VKBA 6515

Technical Bulletin – December 2015

FORD: FIESTA V, FUSION, FOCUS

Car model codes: JH, JD, DAW, DBW, DNW, DFW

MI-542627

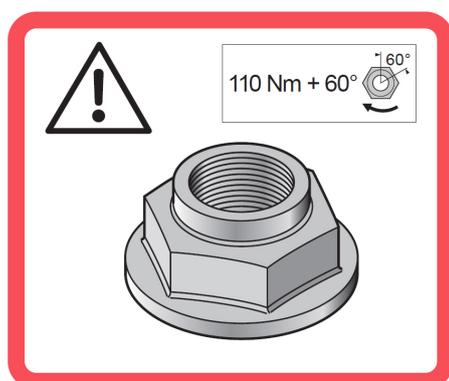
SKF has decided to change the nut in VKBA 6515, due to updated FORD OE recommendations.

Note: The included nut at kit VKBA 6515 has a new design and needs a different torque compared to the old design. It is crucial to follow the instructions when torquing the new nut since this is a **safety aspect**. See torque values stated at the warning label below.

Caution, when fitting the wheel bearing kit VKBA 6515, it's mandatory to use the new nut included in the kit. Never reuse an old nut!
